**I-40 Pigeon Gorge  
North Carolina  
Existing NCDOT Bridges  
Field Review August 28<sup>th</sup>, 2019**

## **1.0 INTRODUCTION**

## 2.4 Fines Creek Interchange Bridge

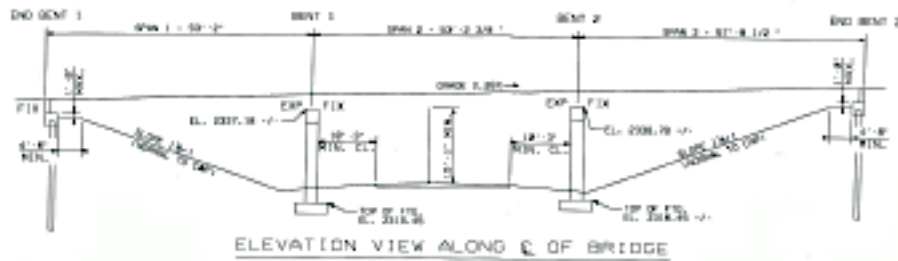
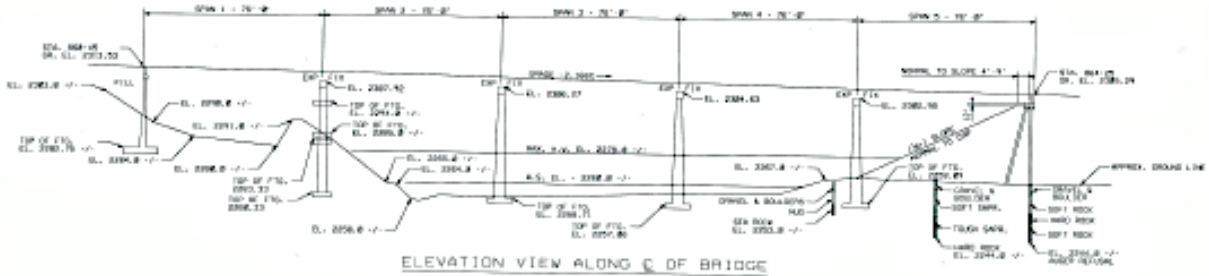
Both proposed replacement structures will significantly reduce the overall openness of the bridge to a width of less than 40 feet essentially matching the existing two-lane road. Studies and experience have shown that elk are hesitant about passing through box culvert structures, especially when they are dual purpose i.e. functioning as a road as well as wildlife passage. The Fines Creek Road appears to carry a large number of trucks accessing the nearby landfill creating noise likely early to late in the day. The probability of this structure functioning as an effective wildlife crossing regardless of the proposed replacement designs as discussed in the field with NCDOT and its consultant Benesch is low.

The installation of 8 ft diameter corrugated steel plate culvert or equivalent sized precast concrete box culverts on one or both sides of the proposed new structures where the existing slopes are currently prior to these areas being backfilled. While these will not be used by elk, smaller animals such as deer and black bear are known to use these more confined types of crossing structure.
